Notice of Allowability

09/628,929

CARGNELLI ET AL.

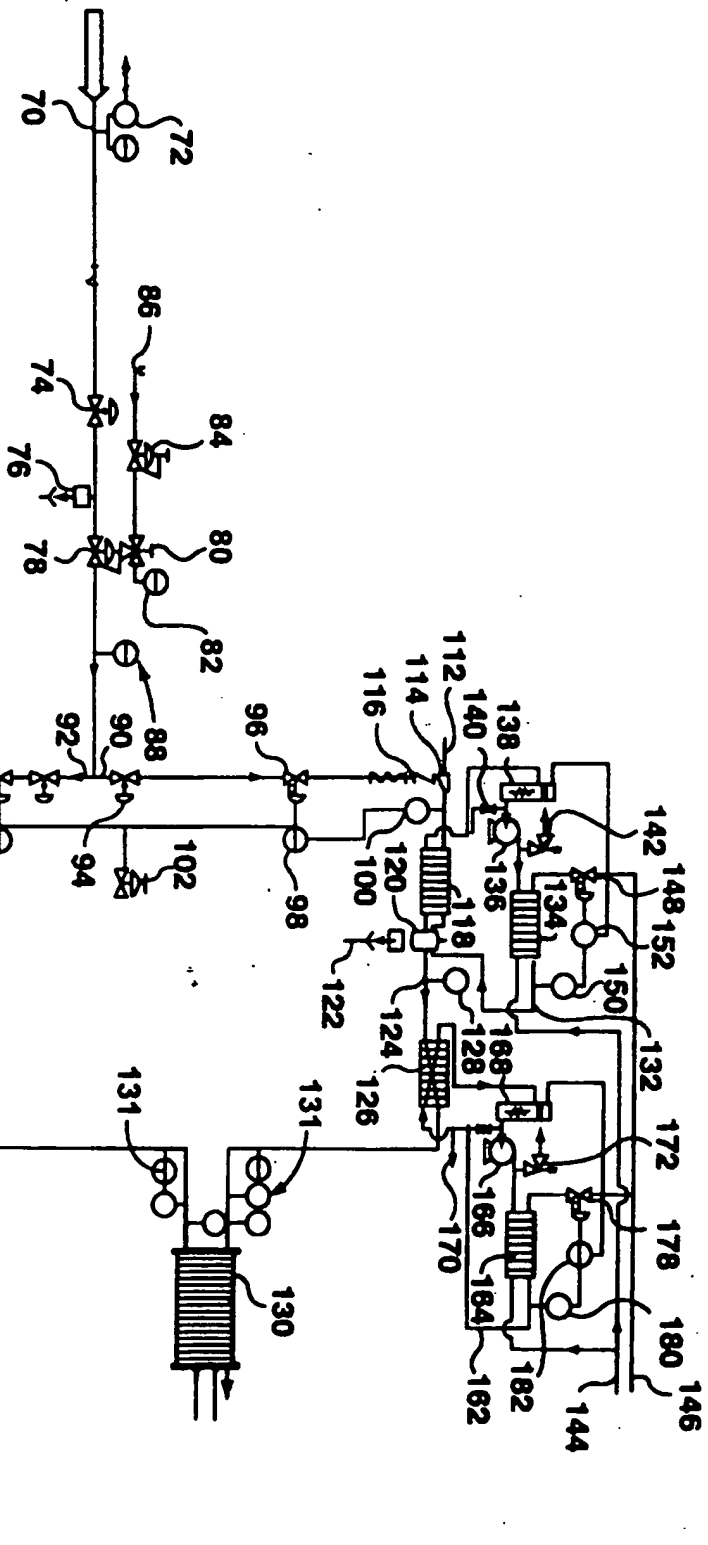
Most notably the heat exchanger (newly legended 134a) immediately below heat exchanger 118a in originally filed Figure 7 now has a plurality of fluid connections associated with it that are not supported by the original specification, claims or drawings. The fact that the systems in the upper and lower portions of Figure 7 are disclosed as similar on page 9, lines 8-12 of the originally filed specification (note the term "many" and not "all" being used to describe the correspondence of the elements between the upper and lower portions of Figure 7) does not permit applicant to engage in wholesale reconstruction of drawing Figure 7. Conduits 144a and 146a are also new and unsupported by the original disclosure.

Not approved

new mall
